Re: Revised Site Plan, Additional Info  
4 Maynard Road, Sudbury, MA

Re: CR Values and Functions  
4 Maynard Road, Sudbury, MA

I've looked over the revised plan dated 4/27/17 dropped off today and have a few comments.

PROPOSED SEWAGE DISPOSAL SYSTEM

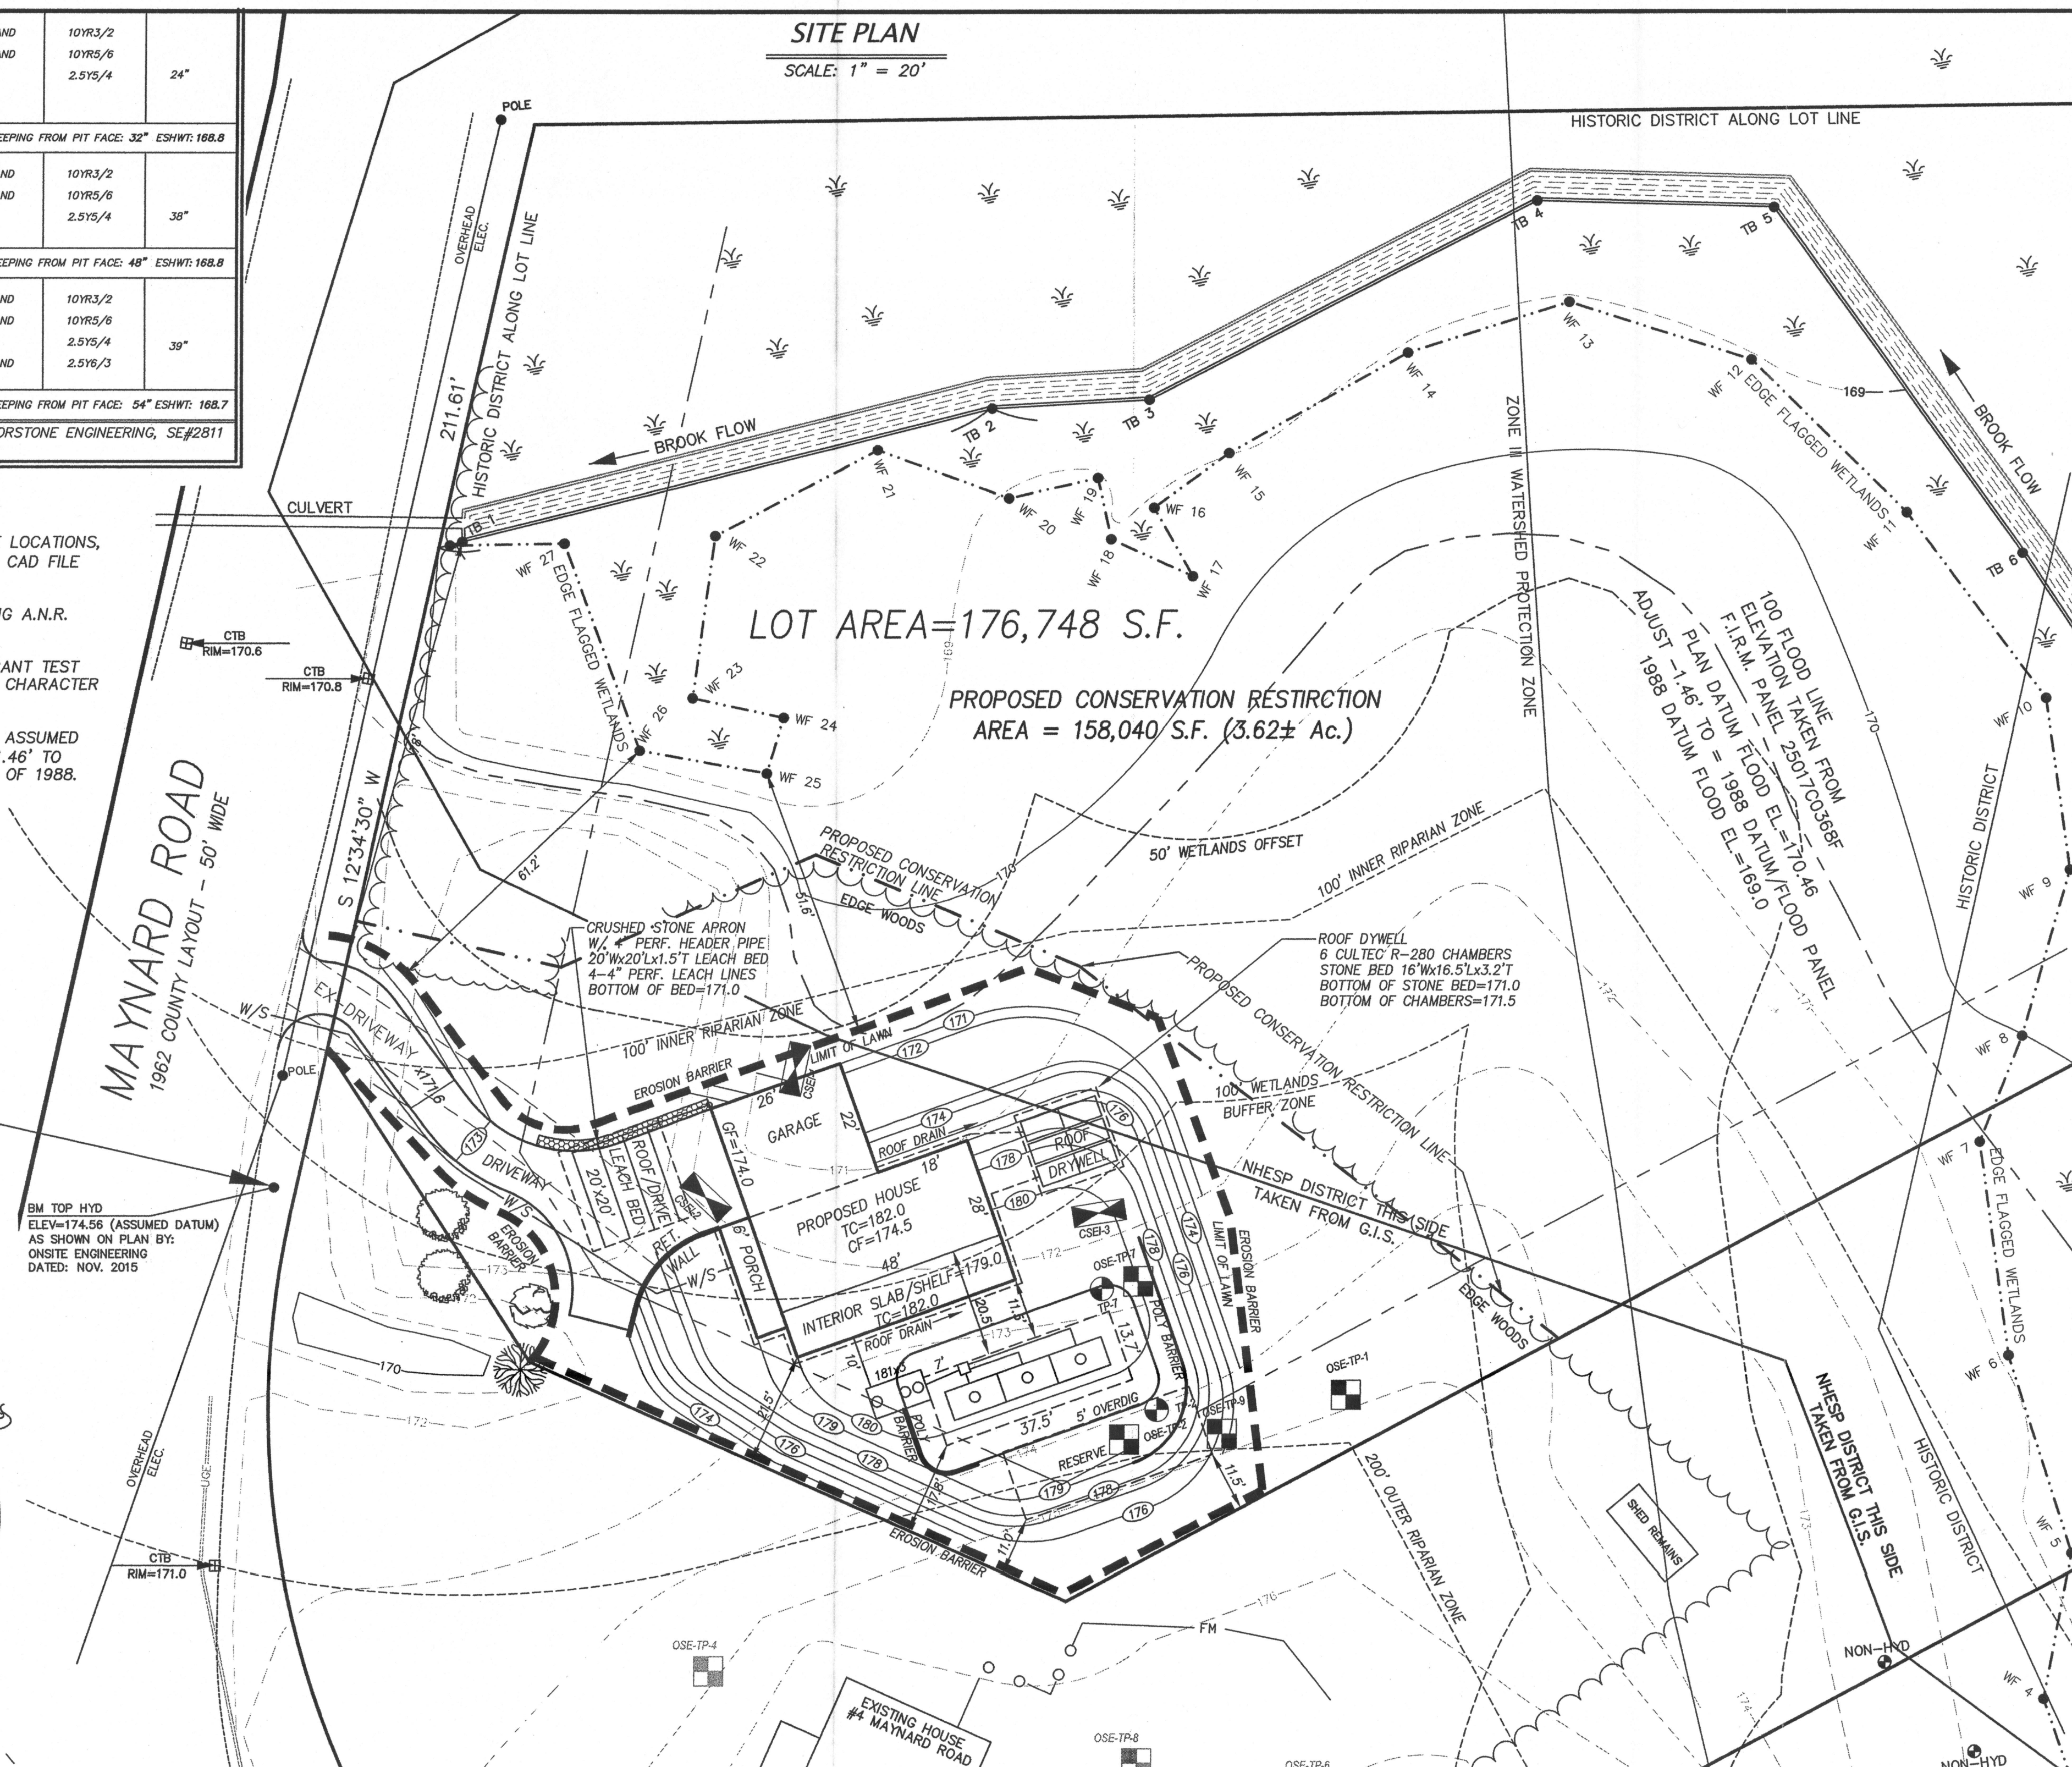
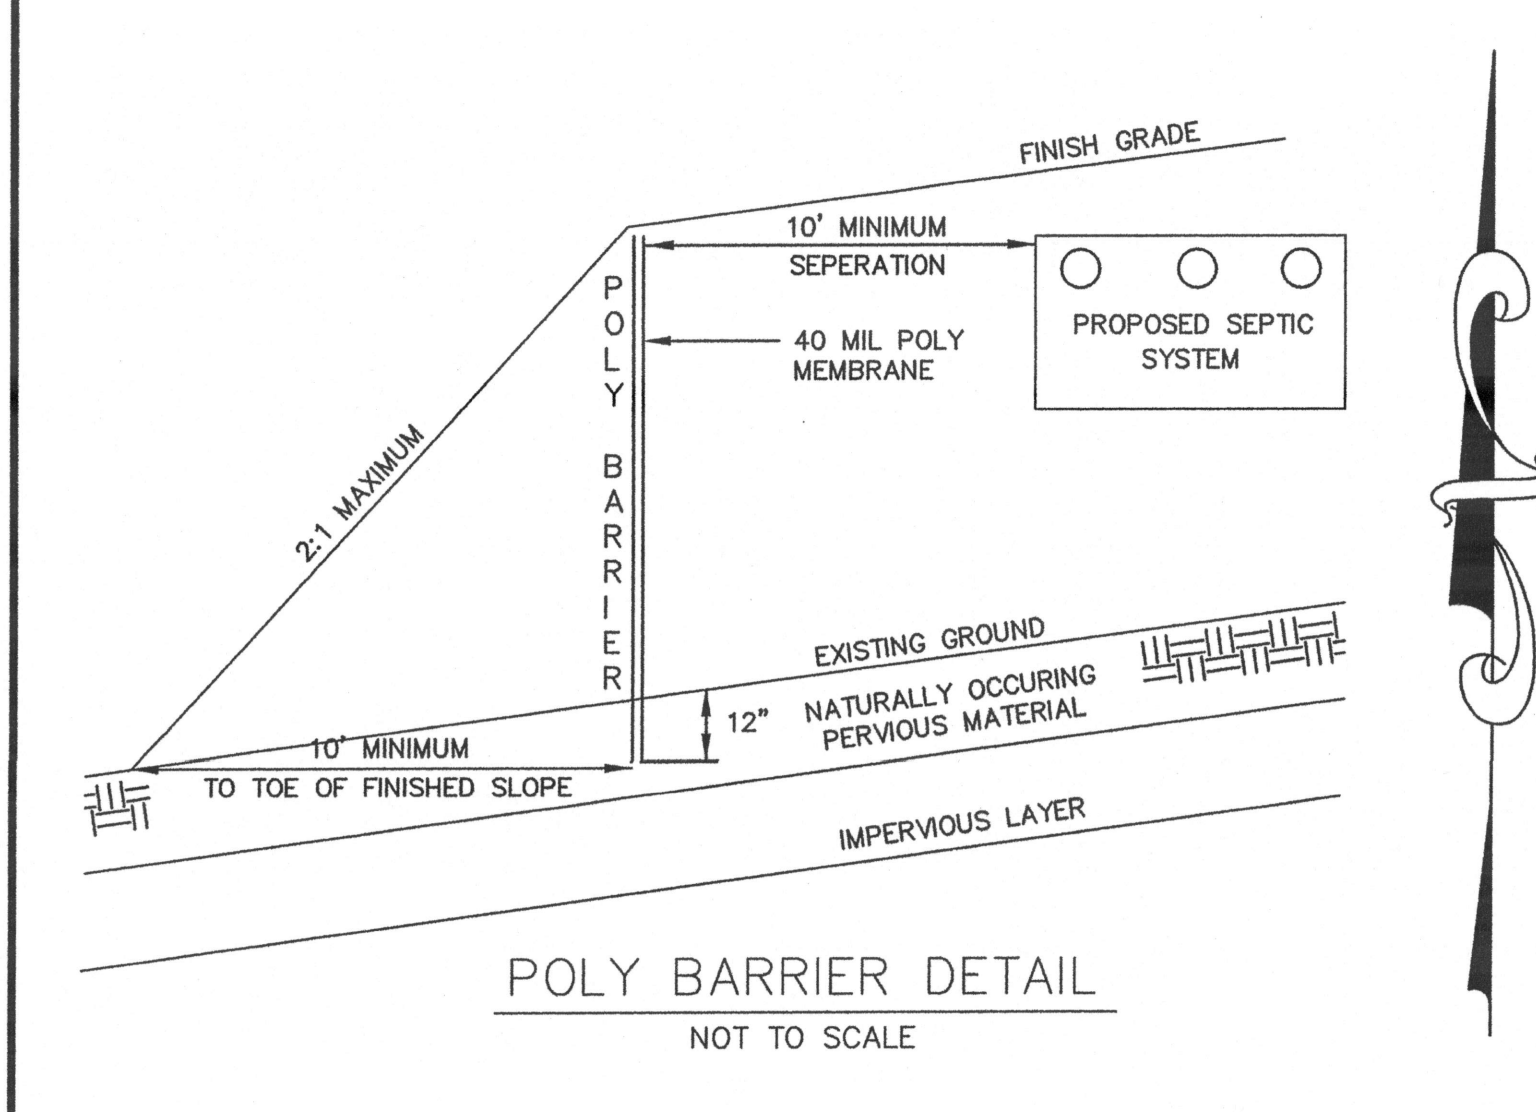
1. I have reviewed the flood plain elevation issue with our Town Engineer as it relates to the datum issue with the flood plain elevation. Generally, the flood plain is shown as an elevation that relates back to the flood maps. I understand what the engineer has done with the adjustment, however, we have no way to confirm the line shown as the 100 year floodplain on the plan is the actual floodplain elevation. It appears that the underlying datum was arbitrary but we do not know what it is so we have no way to confirm the correction factor used. Looking at Zone AE on the FIRM panels, the distance appears that it might be relatively correct.

2. Is the edge of woods shown on the plan the existing or proposed edge of woods? Based on previous comments at the hearing, I believe it should be existing. If so, the CR line should be moved to the edge of woods as this will encompass the invasive species removal area, which is also proposed as part of the mitigation.

3. There is only a 14 sq. ft. margin of error for the allowable extent of alteration in the RFA before the 10% disturbance is reached. I suggest adding the limit of lawn to the plan. Is it the hay bale line? The NOI indicates that 6,538 sq. ft. beyond the haybales will have invasives plants removed. If this area is considered an "alteration", total site alteration will be beyond the limit permitted in the RFA.

5. I do not see soil testing specific to the areas of proposed infiltration. For example, the drywell to the northeast shows (on Jan. 15, 2015) the bottom of the stone bed at elevation 171'. The closest test pit #7 shows estimated high water table at 171.48'. this test pit is at least 22' upgradient from the leach pit.

- Revised site plan by Connorstone Engineering dated 5/17/17:
  - Updated floodplain data
  - Revised CR line to edge of woods
  - Additional test pits
  - Sheet 2 with layout of CR area (dated 5/3/17)
- Additional Information:
  - Communication with Gary Bogue on 5/19/17 at MassDEP NERO confirmed that invasive plant removal by hand only (i.e. no motorized vehicles such as mowers or brush hogs) will not constitute as an alteration, and will act as a benefit by restoring the native plant community.
  - A letter discussing the alternative lot line has been provided by Rose Chaulk, who is the land surveyor associated with the project.
  - An assessment of the wildlife habitat in the CR has been provided by Goddard in a document dated 5/28/17.

**PROPOSED SEWAGE DISPOSAL SYSTEM**

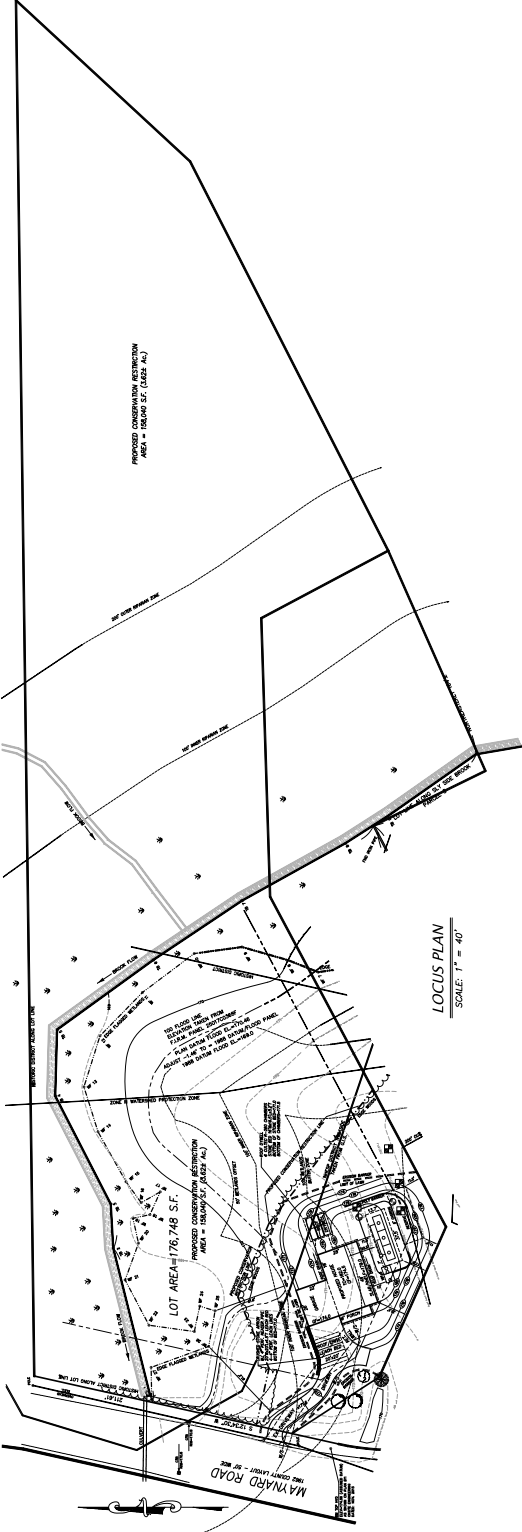
6. A CR is proposed for mitigation. We will need a plan showing the extent of the CR on the 3.54 acres.
7. I had previously discussed with Dan the need to provide an assessment of the RFA to be disturbed (which did have a description of the wildlife habitat values in the NOI), as compared with the values and functions of the area to be placed in the CR. The intent is to show that the area proposed for permanent protection provides greater protected (WPA & bylaw) values and functions than the area to be lost. I did not see this evaluation/comparison in the NOI.
